<b>Project</b>	Steamboat Base Village Redevelopment	<b>Date</b>	06/21/2021
<b>Project Location</b>	Steamboat, Colorado	<b>Architect's Project Number</b>	03.7835.000
<b>Owner/Client</b>	Alterra Mountain Company / East West Partners	<b>File</b>	6BL <b>This is page</b> 1 of 3
<b>To</b>	Saunders Construction Inc.	<b>Attention</b>	Bryan Sculthorpe
<b>Address</b>	86 Inverness Place North		
<b>City</b>	Englewood	<b>State</b>	CO <b>Zip Code</b> 80112
<b>Delivered via:</b>	<input type="checkbox"/> Messenger	<input type="checkbox"/> Hand carried	<input type="checkbox"/> Facsimile
	<input type="checkbox"/> Express	<input type="checkbox"/> Pick-up	<input type="checkbox"/> E-mail Address
	<input type="checkbox"/> Mail	<input type="checkbox"/> UPS	<input checked="" type="checkbox"/> Website Address BIM360

<b>Attachments</b>	BP3 - BULLETIN 01		
<b>Requested by</b>	<input checked="" type="checkbox"/> Architect	<input type="checkbox"/> Owner	<input type="checkbox"/> Contractor
	<input type="checkbox"/> Other (specify): _____		
<b>Issued by Gensler by</b>	Jacob Apple	<b>Date Signed</b>	06/18/2021
<b>Issued by Owner by</b>		<b>Date Signed</b>	
	<input type="checkbox"/> Required; Please return signed

**1A-C.201**

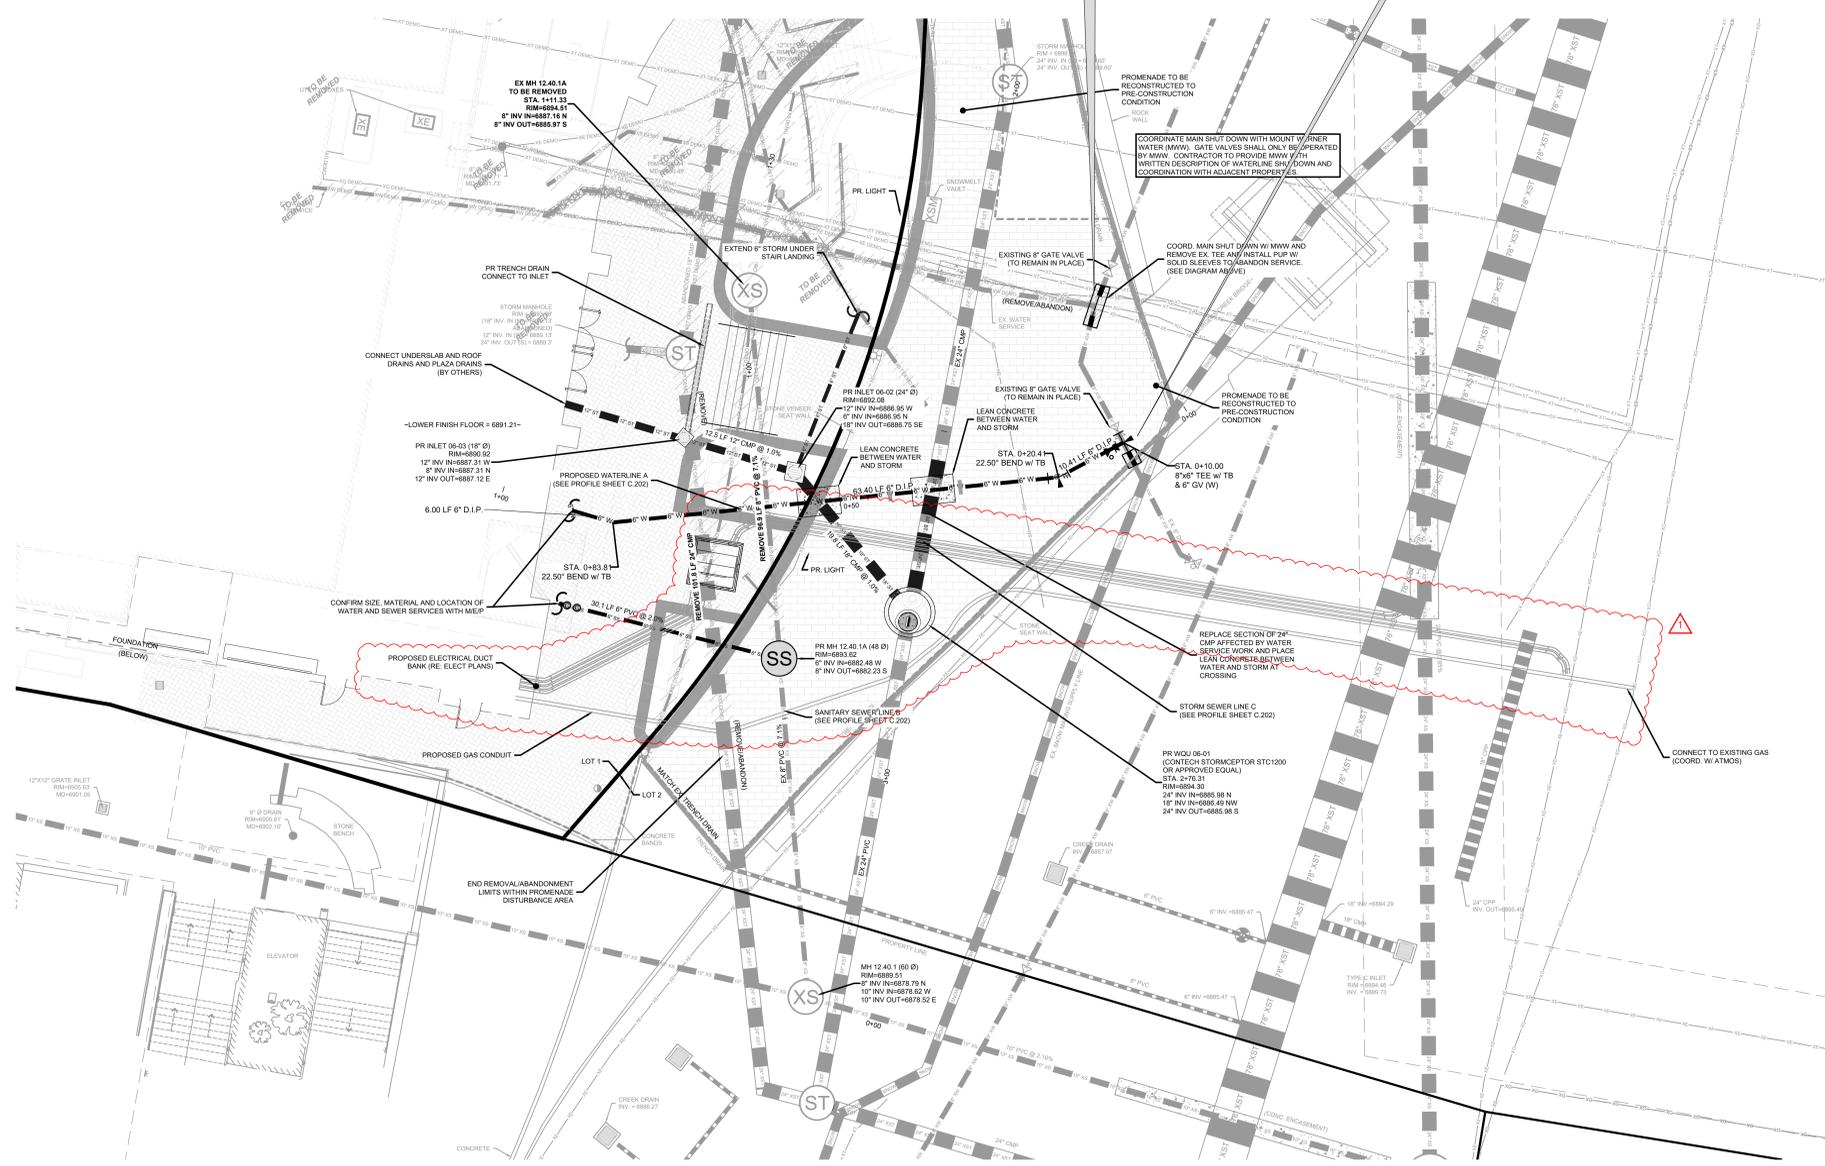
1. 1A-C.201 – DETAILED UTILITY PLAN
  - a. Updated plan to reflect new transformer location and probable duct bank/conduit alignments.
2. 1A-C.210 – CONDUIT EXHIBIT
  - a. This is a new sheet that depicts the probable duct bank alignment and profile.
3. 1A-C.301 – SEGREGATED CIVIL GRADING PLAN
  - a. This plan reflects the revisions to the retaining walls to accommodate the transformer location.

**1A-L0-01**

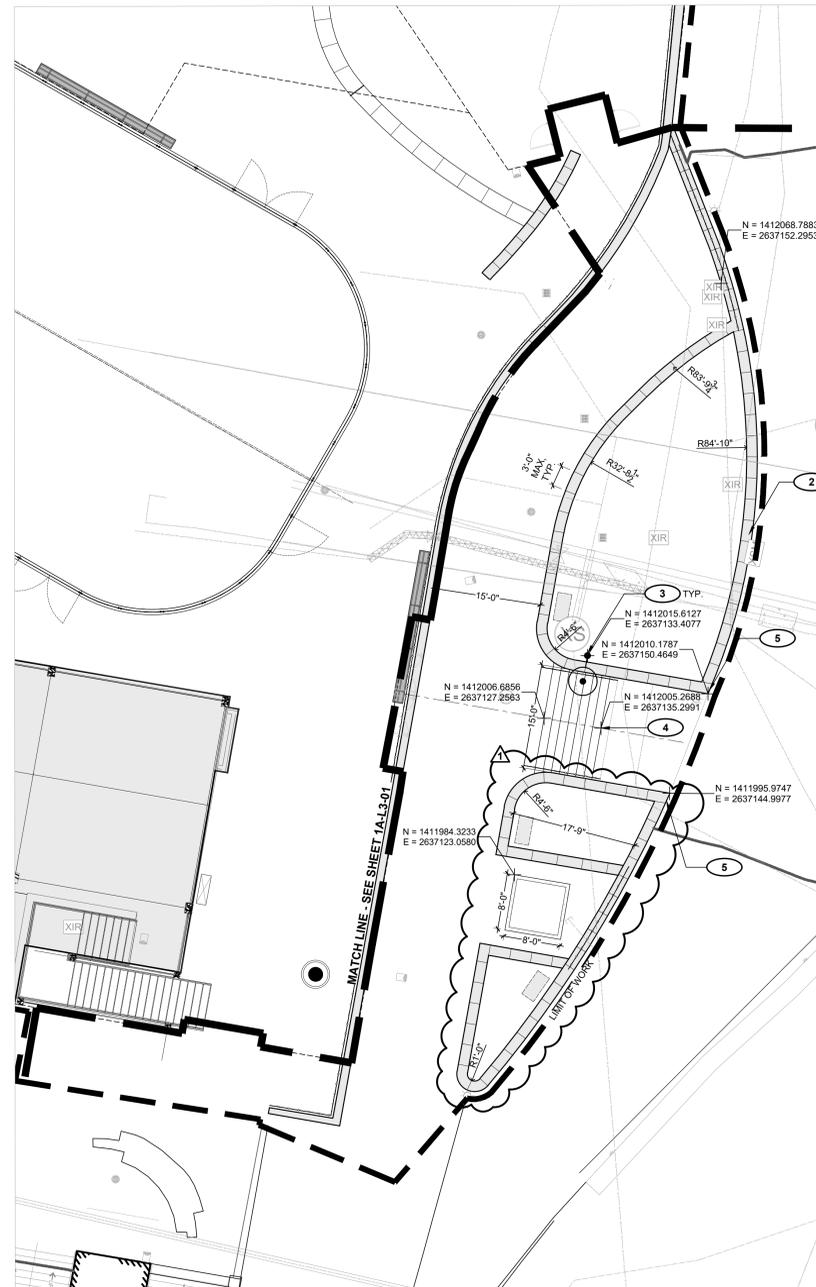
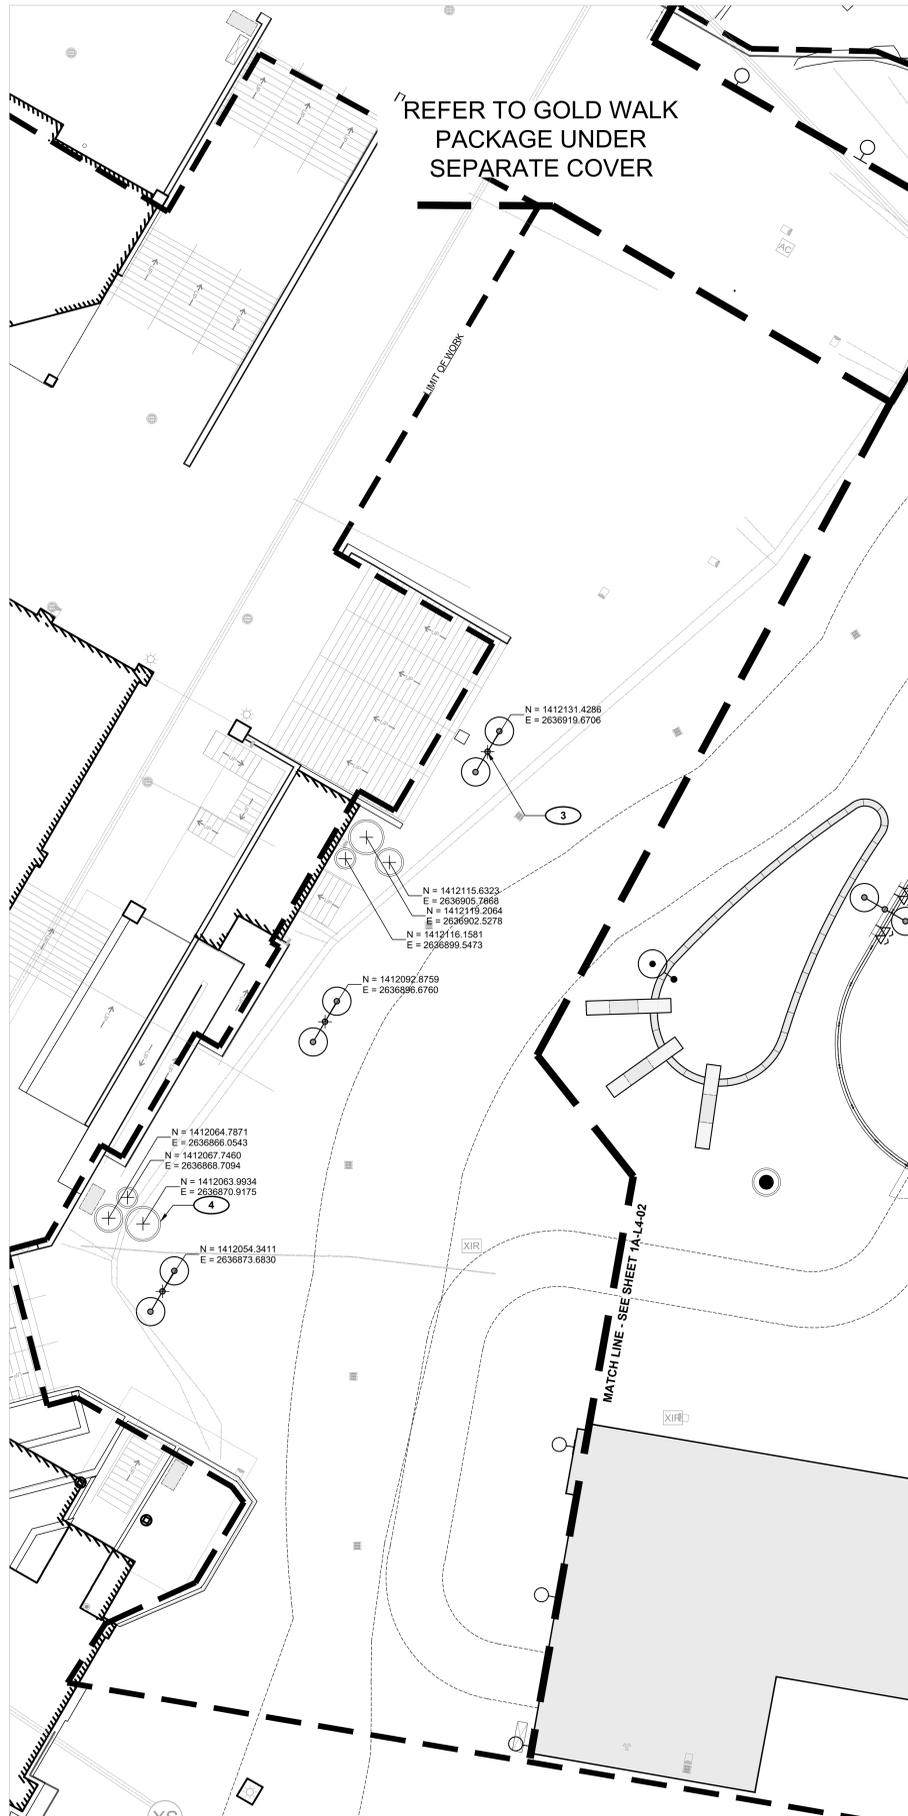
1. 1A-L0-01 Hardscape Reference Plan
  - a. Southern promenade planter walls reconfigured to accommodate transformer.
2. 1A-L3-02 Site Materials Plan
  - a. Southern promenade planter walls reconfigured to accommodate transformer. Transformer pad placed at lower promenade level.

1A-L4-02

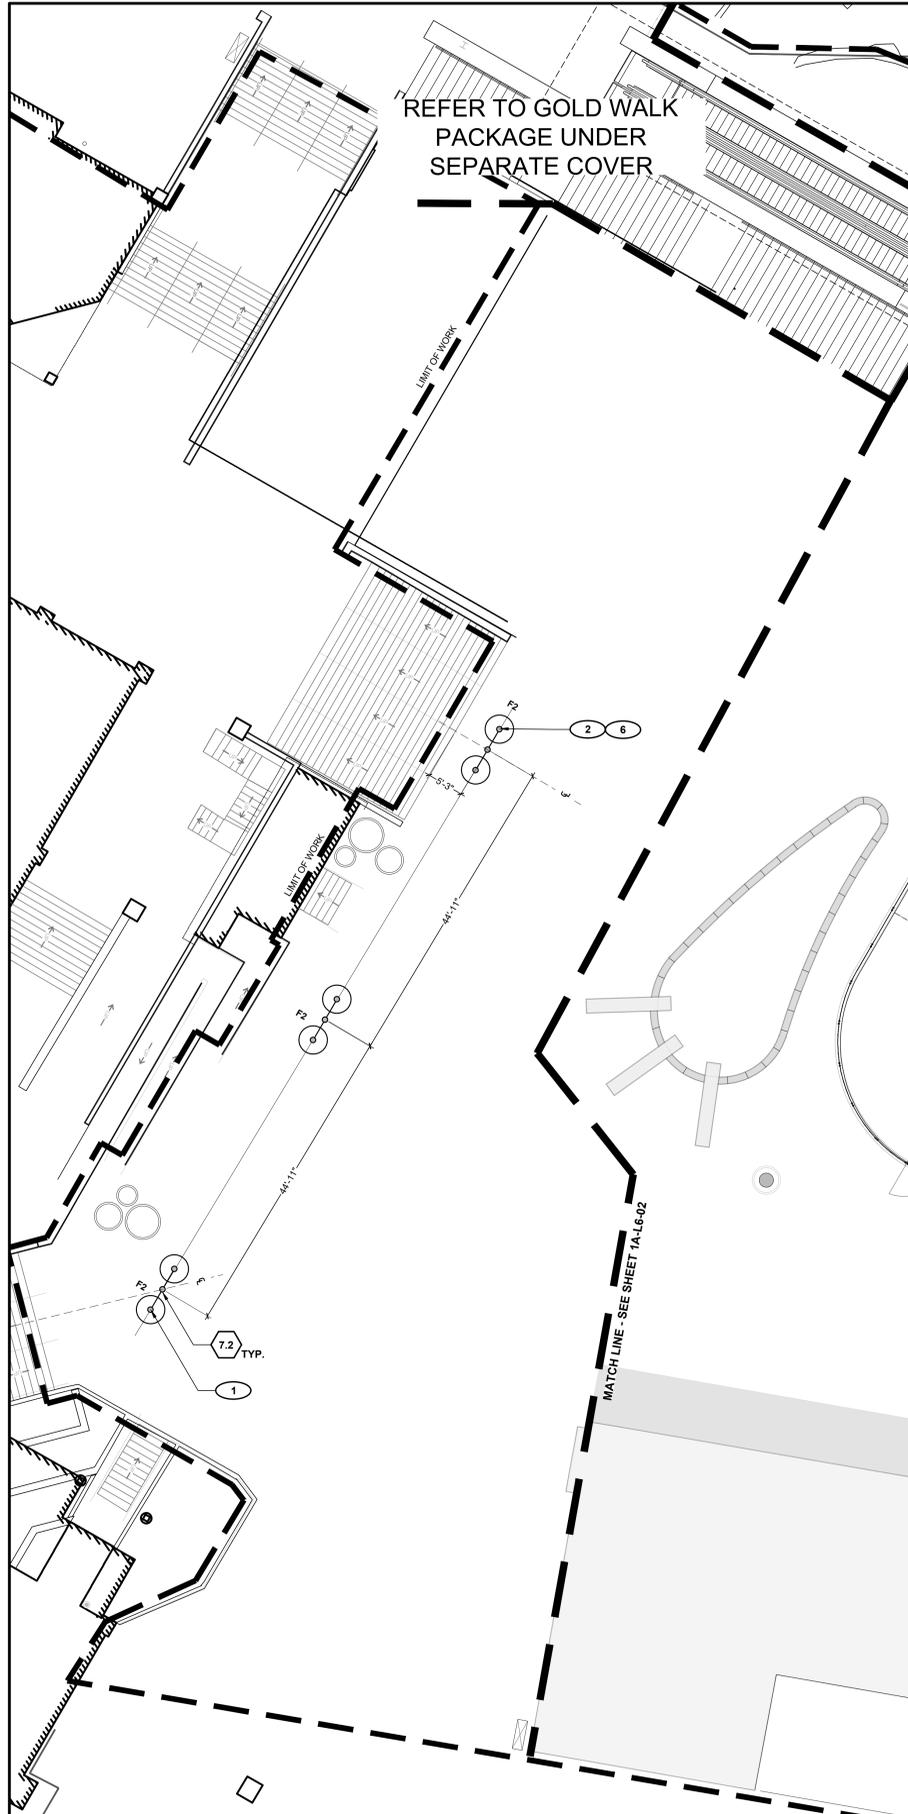
3. 1A-L4-02 Site Layout Plan
  - a. Southern promenade planter walls reconfigured to accommodate transformer. Transformer pad placed at lower level. Dimensions added.

**1A-L6-02**

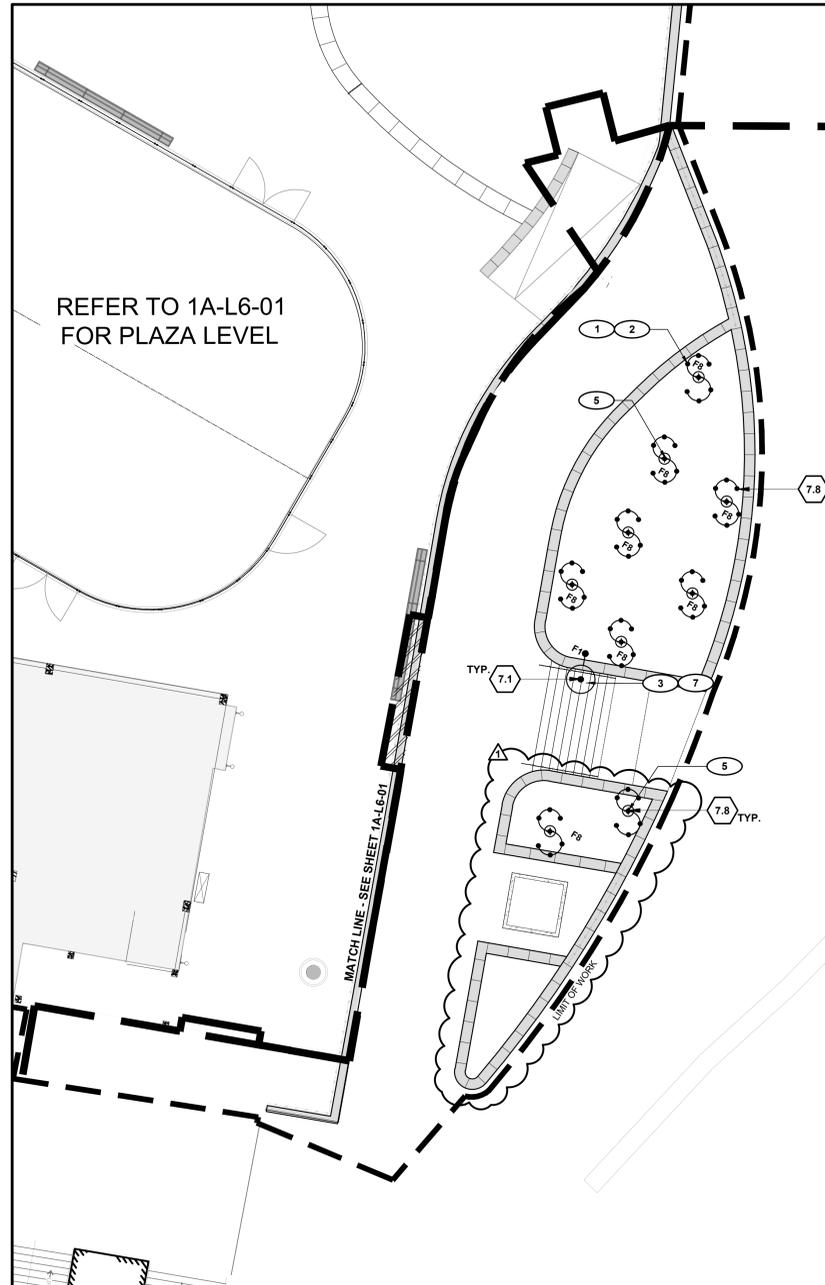
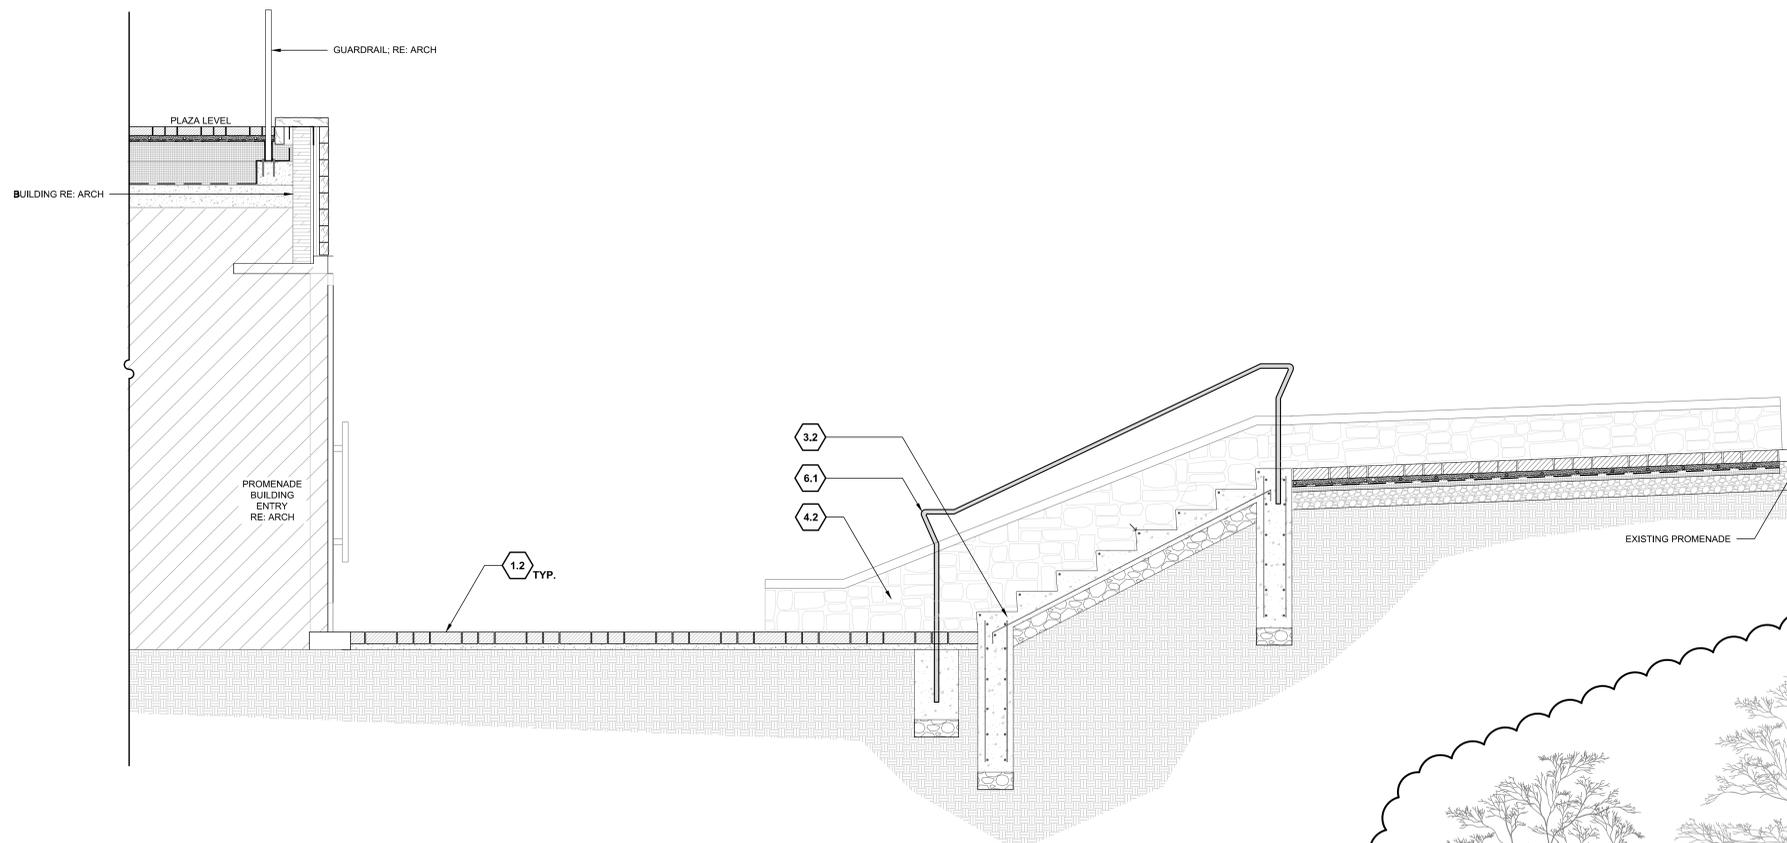
4. 1A-L6-02 Site Lighting Plan
  - a. Fixture Type F8, tree mounted lights redistributed in southern promenade planter to accommodate new wall layout.
5. 1A-L7-08 Composite Sections
